# **SERVICE PROCEDURE**

**G-12511  
JUNE 2012**

**SUBJECT: SAFETY RECALL**  
**Bendix® ATR-6™ brake valve on certain DuraStar®, WorkStar®, 9800, LoneStar®, and ProStar® truck models built 12/02/2010 thru 01/26/2012 with traction control or stability control and operate in Line Haul service that were not included in previous releases.**

**FIGURE 1 - BENDIX® ATR-6™ TRACTION RELAY VALVE**

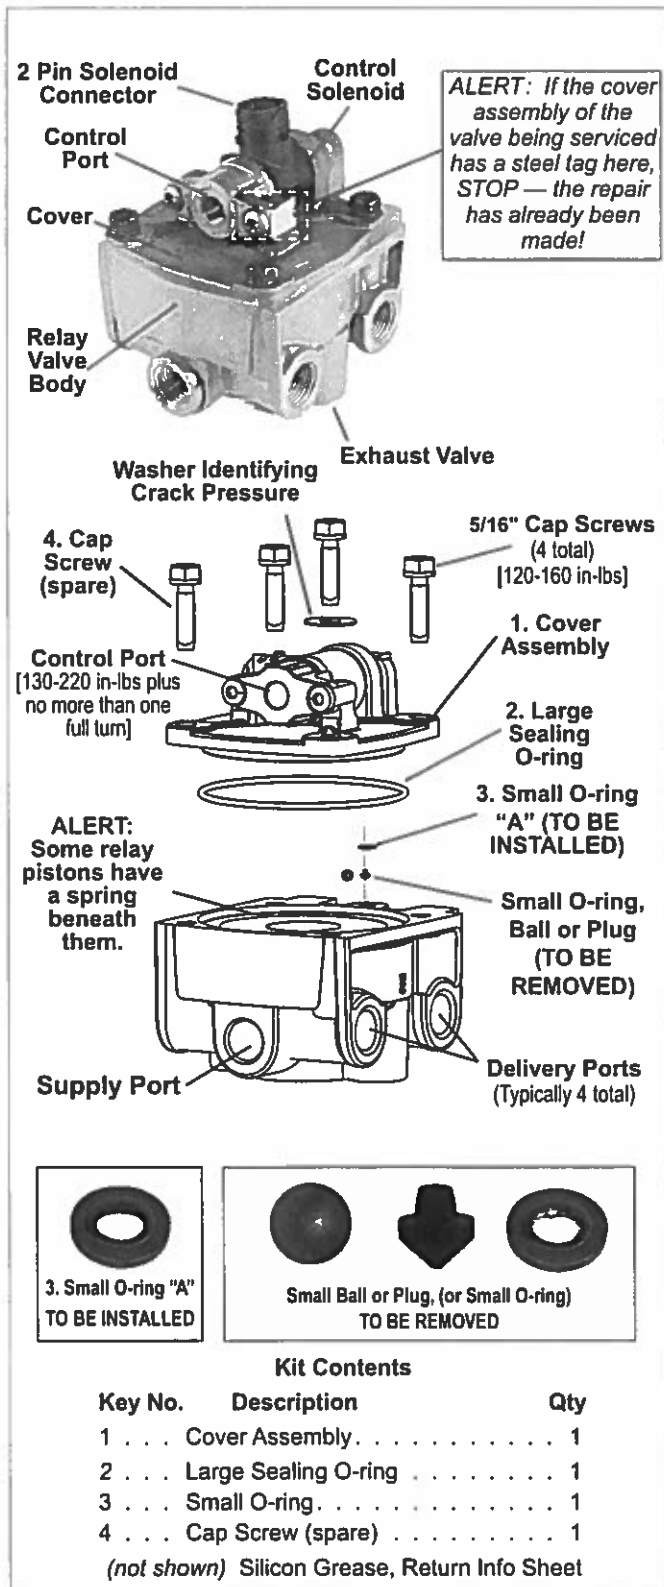
1. Verify that the Bendix® ATR-6™ valve does not have a steel tag (See Figure 1) that indicates it has already been serviced.
2. **Clean the valve and take care to avoid any contamination inside the valve during these procedures.**

6. • **Remove and discard the ball or plug ("A" in Figure 1) from between the cover and the valve, OR,**  
• **For ATR-6 valves that have not been serviced by a temporary disable kit, there will not be a ball or plug; remove and discard the original small O-ring.**

7. Remove and discard the large sealing O-ring.
8. Grease and install the new large sealing O-ring(2) and the small O-ring (3) supplied, into the NEW valve cover.

9. Verify that no contamination has entered the valve. You MUST remove any debris inside. Use a clean shop cloth/shop air and use the supplied grease to replace any removed. With the replacement cover assembly (and mounting bracket) in the same orientation as the original, place the cover assembly into position over the valve body.

USE HAND-WRENCHES (ideally torque-wrenches) to re-install the four cap screws and I.D. washer in the cover and torque (in a cross-pattern) to 120-160 in-lbs. NOTE: All torques specified are assembly torques and can be expected to fall off slightly after assembly. Do not re-torque after the initial assembly torque falls off; **Do not over-tighten — overtightening could crack the cover or strip the threads.**
